Second Revision No. 54-NFPA 80-2023 [Global Comment]

Second Revision No. 46-NFPA 80-2023 [Detail]

Second Revision No. 48-NFPA 80-2023 [Detail]

Figure A.4.4.4.4 Example of a Vision Light Kit.

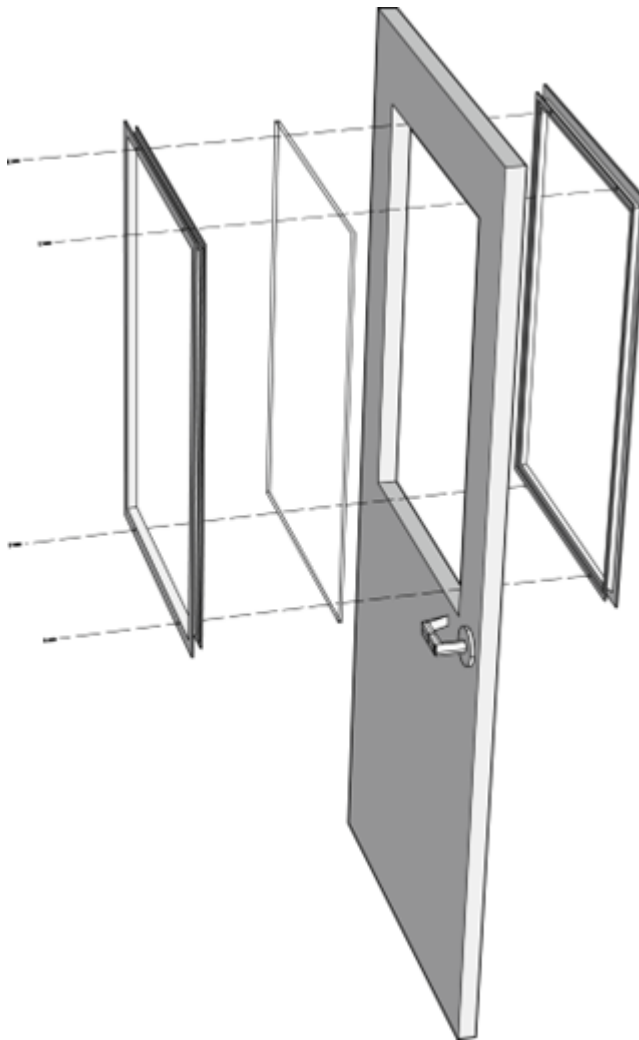
A.4.4.4.4

Some universal metal glazing kits are relatively easy to install in the field. Such glazing options are extensively used within the fire door industry and identical glazing units can be installed in a wide array of fire-rated doors (e.g., wood, hollow metal, and so forth). Starting in the 2025 edition of NFPA 80, field installation of such glazing options is permitted for all fire doors, including new wood doors. (See Figure A.4.4.4.4.)

Committee Statement: The new annex and figure are provided to guidance for field installed vision light kits.
